EnergyAustralia™

EnergyAustralia's submission to

Australian Competition &
Consumer Commission

Response to ACCC's Draft
Determination for EnergyAustralia's
Revenue Cap 2004-2009

Figure 5.3 Comparison of TNSP's opex per asset base

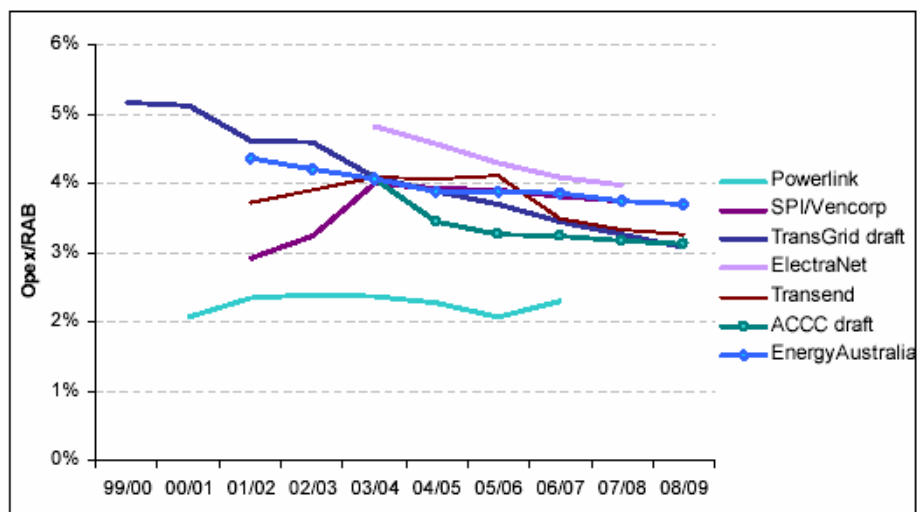
However, one of the graphs is outstanding in its analysis. EnergyAustralia draws ACCC's attention to its benchmarking as provided in Figure 5.3 of the draft decision, in which EnergyAustralia's opex to asset base ratio is compared to that of other TNSPs. This Figure is reproduced below.

Figure 5.3 shows that EnergyAustralia proposed a program resulting in a ratio of opex to asset base that would deliver modest efficiency gains. While EnergyAustralia reclassified some assets from distribution to transmission, it would be reasonable to expect that the opex associated with those assets should also be transferred from distribution to transmission, as was the case. We refute the claim that the movement of assets from distribution to transmission should result in a lower opex to asset base ratio due to the operating costs associated with the greater number of transmission assets.

The ACCC's analysis attempts to analyse the relationship between the number of assets to be maintained and the level of anticipated operating expenditures. From the analysis, there are a number of conclusions that can be drawn:
